Service-Bulletin

Washing machines

599 530 226 EN

Toploader Leaky at the rear panel

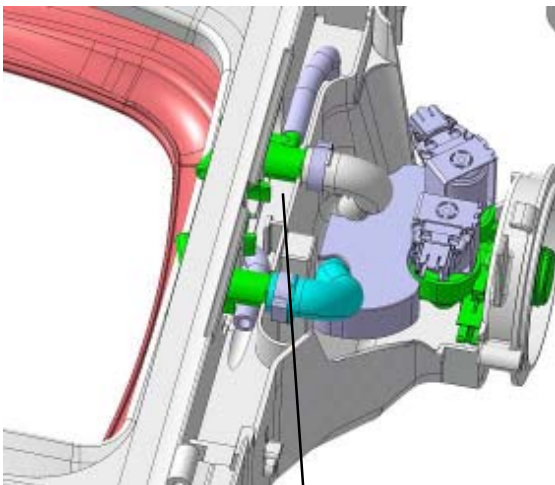
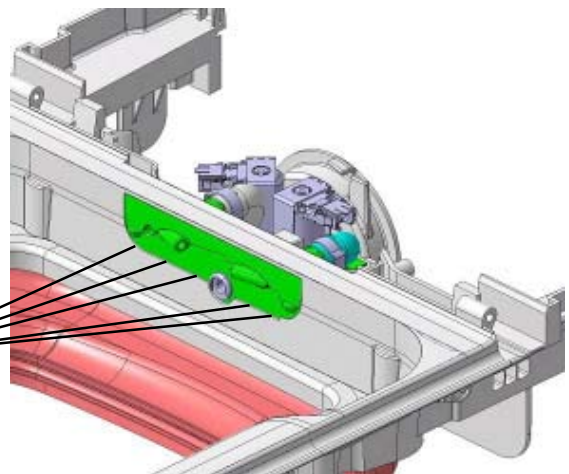
Cause: Affected are only appliances with series no. 723 which have a water distributor from the tool no. 2.
Water is pressed between the upper part and the water distributor in the area of the inlet valve during the filling process of the softener (only when both inlet nozzles are selected).

Leaky between upper part
and water distributor

Water level increases

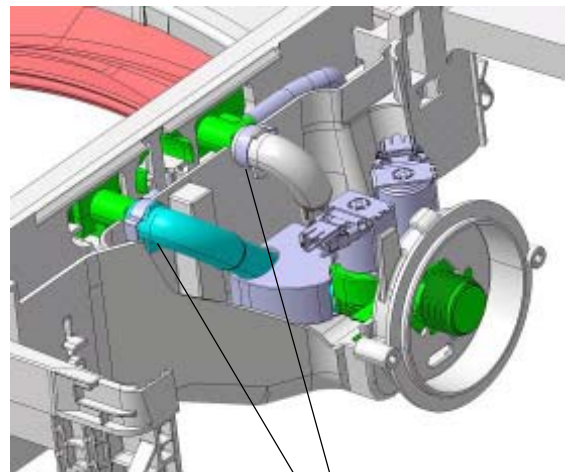
Water runs over between hose and upper part

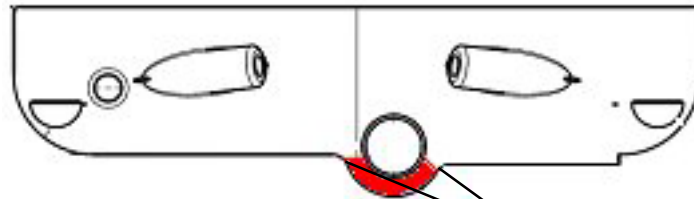
Remove the marked part at the water distributor.

Measure: Remove the stud at the water distributor. Thereby the water can flow back again into the tub.
